Informal meeting on Code of Practice for Packing of Cargo Transport Units

Blocking and bracing material and arrangements

Submitted by ETS Consulting

This document proposes changes to Annex 7, clause 2 on Packing and securing material and clause 4 on Securing of cargo in CTUs.

Figure 7.7 Properly cut and nailed wedges

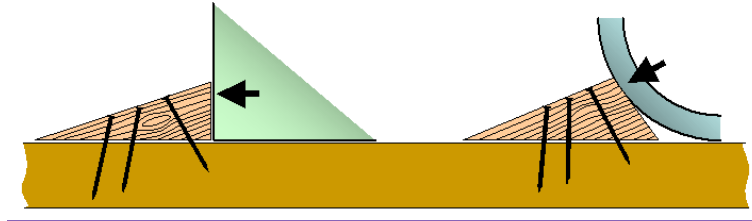
2.3.5 Blocking that is secured using mechanical fixings by nailed on scantlings bedding or spreader beams should be used for minor securing demands only. The different types of fixing will provide a range of shear strengths d Depending on the type, configuration and size of the fixing nails used (examples of fixings can be found in Appendix X).

For example, the shear strength of ~~such~~ a blocking arrangement secured using nails may be estimated to take up a blocking force between 1 and 4 kN per nail. Nailed on wedges may be favourable for blocking round shapes like pipes. Care should be taken that wedges are cut in a way that the direction of grain supports the shear strength of the wedge. Any such timber battens or wedges should only be nailed to dunnage or timbers placed under the cargo. Wooden floors of closed CTUs are generally not suitable for nailing. Nailing to the softwood flooring of flatracks or platforms and open CTUs may be acceptable with the consent of the CTU operator (see figure 7.7).

Figure 7.1 Boundary shoring system

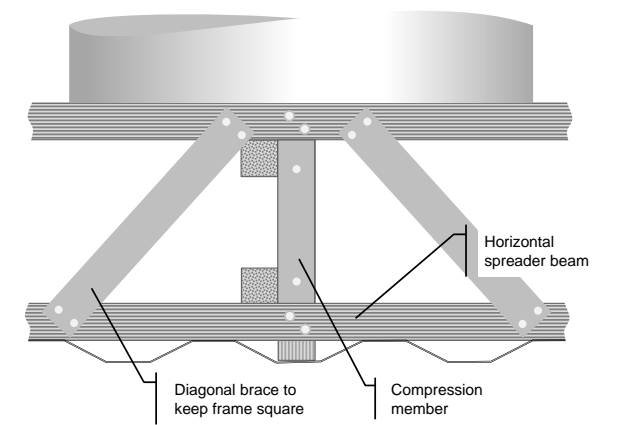
4.1.7.2 Additional shoring may be made against the boundary side and front walls so long as the forces are distributed by spreader beams as shown in Figures 7.1 and 7.2.

Figure 7.32 Blocking in a strong boundary CTU

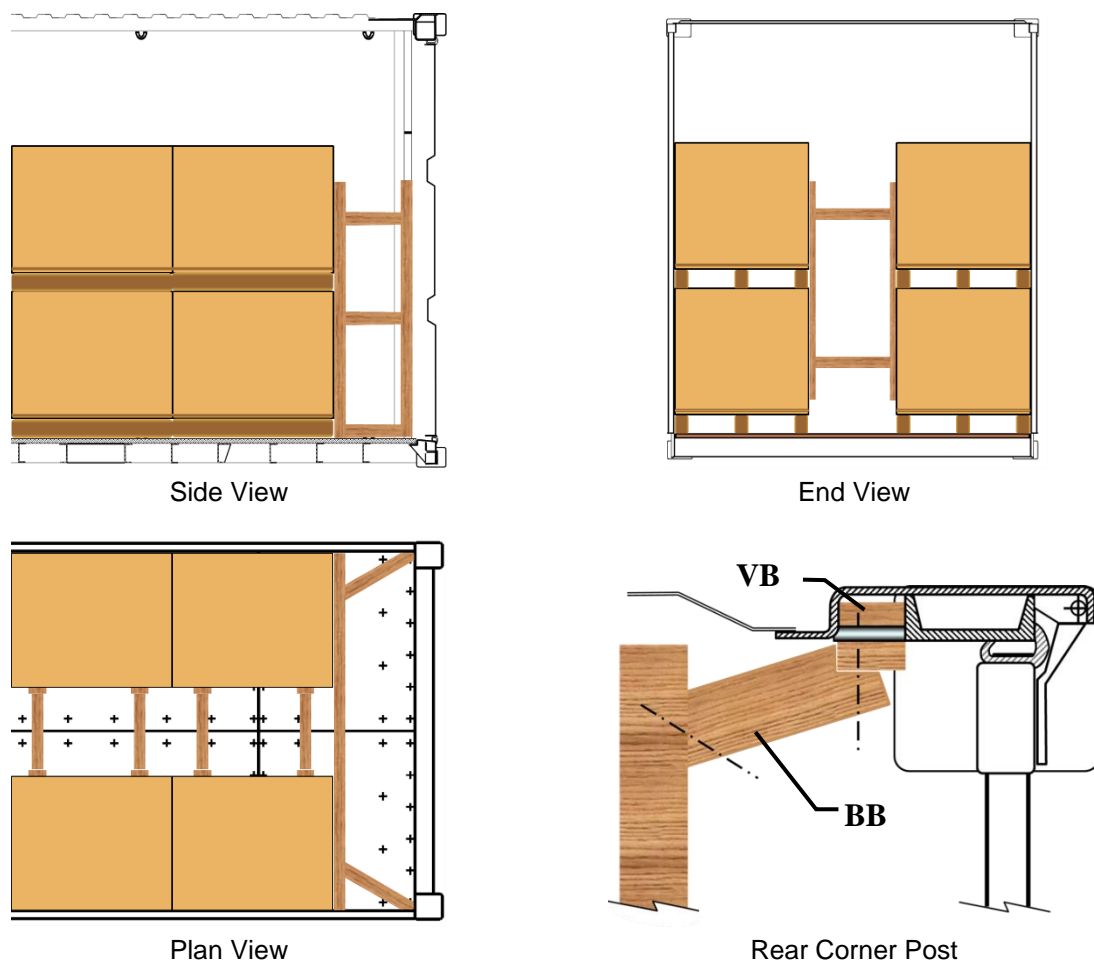
- The principle of securing the load against the corner posts of the container to prevent longitudinal displacements, as shown in 2.3.4, figure 7.6, cannot be applied to the container structures currently used. Therefore, this clause should be reformulated.
- The example of securing a load to the corner posts of the container door opening shown in figure 7.32 is not correct, as the corner posts do not protrude beyond the side walls of the container.

4.2.4 Critical situations may arise, ~~e.g.e.g.~~, with a fully packed freight container in road transport, where longitudinal securing should be able to withstand an acceleration of 0.8 g. The longitudinal wall resistance factor of 0.4 should be combined with a friction factor of at least 0.4 for satisfying the securing balance. If a balance cannot be satisfied, the mass of cargo should be reduced, or the longitudinal forces transferred to the main structure of the container. The latter can be achieved by intermediate transverse fences of timber battens (see subsection 2.3.4 of this annex) or by other suitable means (see figure 7.32). When bracing against the rear corner frames, vertical timber battens (VB) should be inserted into the shoring slots between the slot bars and the bracing battens (BB) fitted against this. Where required nails or other fixings can be used to stabilise the bracing battens.

Another option is the use of friction increasing material.
